ADDENDUM NUMBER THREE (3)**CATAWBA COUNTY****BLACKBURN RESOURCE RECOVERY FACILITY OPERATOR'S BUILDING****PROJECT NO. 26.00701**

This Addendum Number 3 (Three) is issued this the 28th day of October 2026, to all parties who hold a set of Bid Documents for the project entitled: “**BLACKBURN RESOURCE RECOVERY FACILITY OPERATOR'S BUILDING**”. This Addendum Number 3 (Three) shall become part of the Contract Documents and its receipt acknowledged on the bid documents at the time of bidding.

10 STOREFRONT WINDOW SILL 3" = 1'-0"

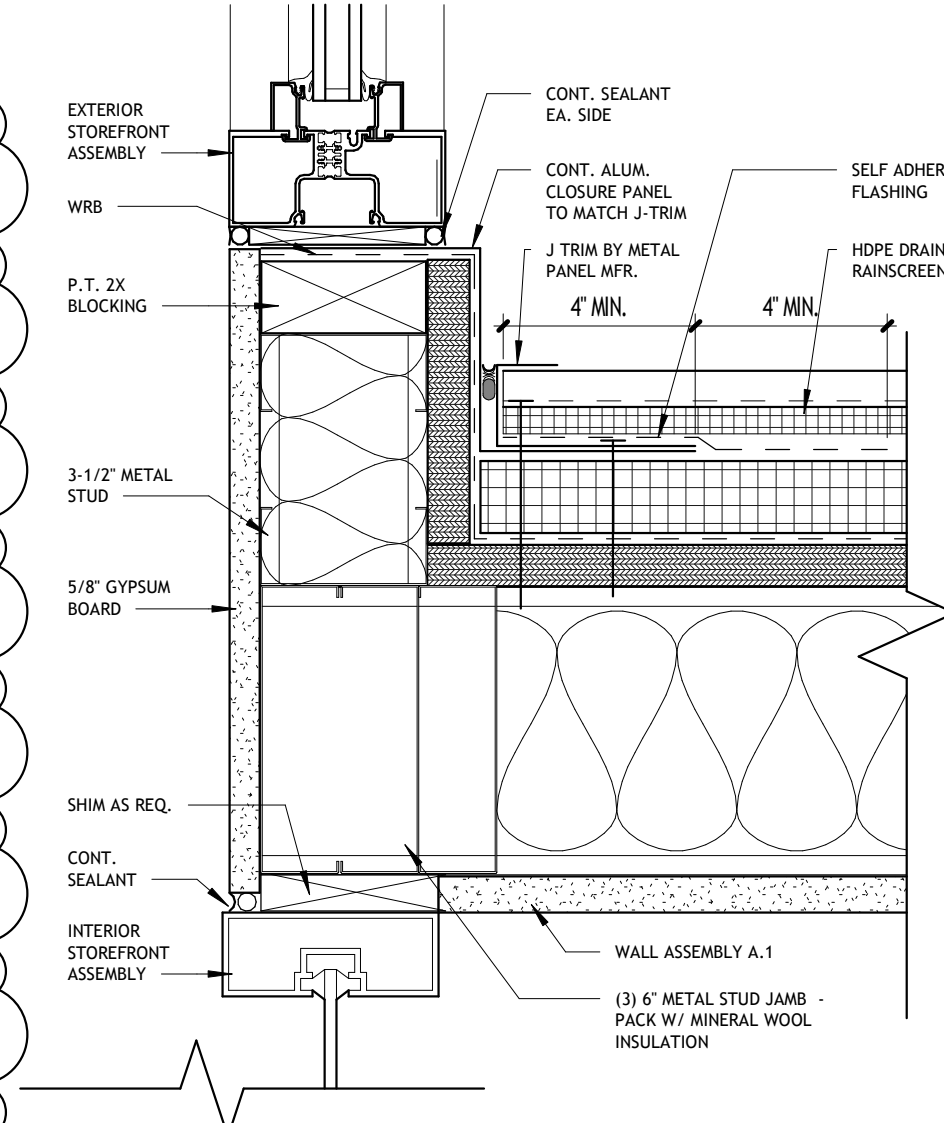
- c. *Sheet A410*: Revisions made to details 9, 10, and 15 clarifying changes in the required window type.
 - d. *Sheet S001-S301*: Revisions made to notes on wall anchoring system.
